PLOT PLAN - PROPOSED CONDITION
12555 GARRETT ROAD
VICTOR AND LUIS CASTANEDA
PEYTON, COLORADO

DATE	REVISIONS
9/23/21	ISSUED FOR PRE-APPLICATION DESIGN REVIEW

FIGURE 2

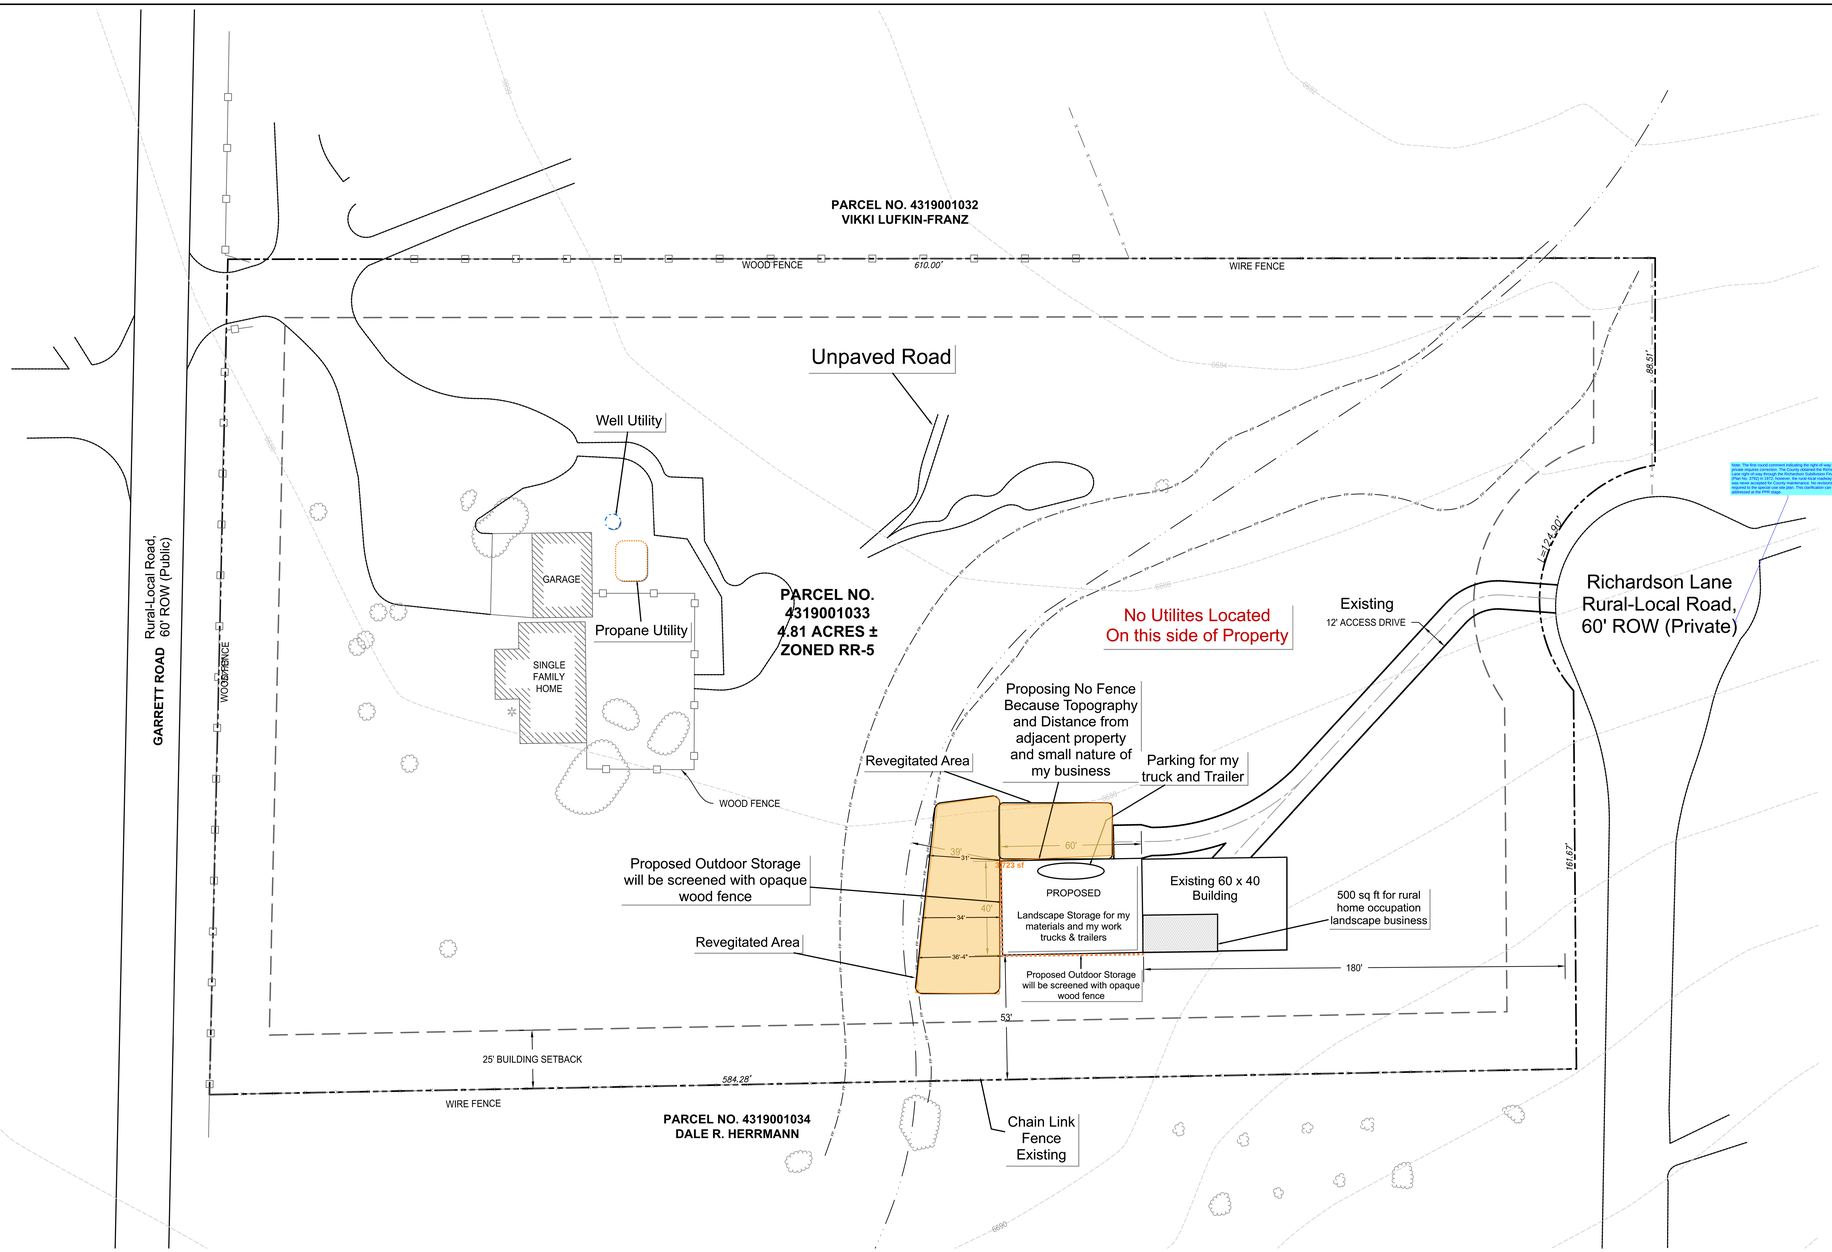
Previous Review #1 comment for reference:
Since 2008, the unvegetated disturbances + added impervious exceed 1ac (I measured about 1.2ac). As such, you can either stabilize/vegetate enough area to get your post-2008 disturbances to <1ac or submit all documents associated with an ESQCP (which is EPC's stormwater permit) and a PCM (which is water quality treatment pond/facility). Regardless, Miranda is going to set up a Site Development Plan review (PPR project prefix on EDARP) and we can address the need for ESQCP and a PCM then. So no need to modify anything on this Site Plan sheet for this AL review.

Review #2 comment:
I see that you added about 3,700 sqft (<0.1ac) of revegetated area to this Site Map with this submittal. Note that for the PPR, you will need to show >0.2ac of revegetated and/or stabilized (like gravel) areas to get below the 1ac threshold described above. No related revisions are needed to the Site Plan for this AL, I'm just providing this info as an FYI for your PPR review.
